# TECHNICAL SERVICE BULLETIN

Bulletin No.:	TSB-002-98	Description:	Rear Hatch Lock Rod
Model(s):	1998-99 Nubira 5-Door	Group:	Body
Date:	November 25, 1998	Reference:	N/A
VIN Range:	See Attached	Prod. Dates:	N/A

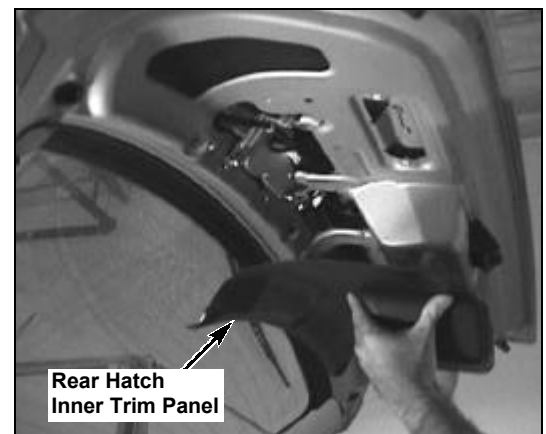
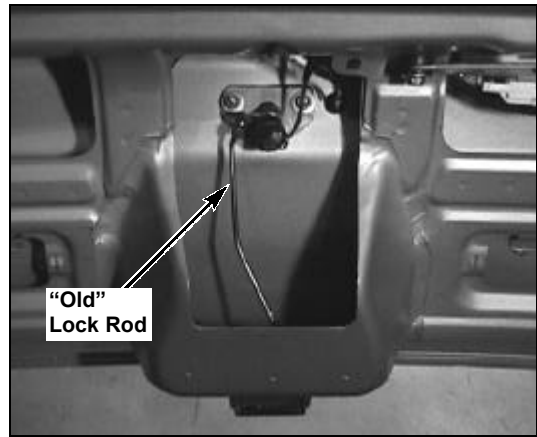
For some Nubira 5-Door models, it is possible that the alarm may be triggered when opening the rear hatch with the key. If the key is rotated slowly, it is possible that the rear latch could be released before the lock switch disables the alarm system. To correct this condition, Daewoo has developed an updated rear hatch lock rod which is 5 mm shorter than the original rod.

1. Raise the rear hatch to its fully opened position.
2. Remove the rear hatch inner trim panel by removing and retaining the four (4) screws and three (3) trim panel clips.

3. Release the two (2) lock rod plastic lock tabs and remove the lock rod.
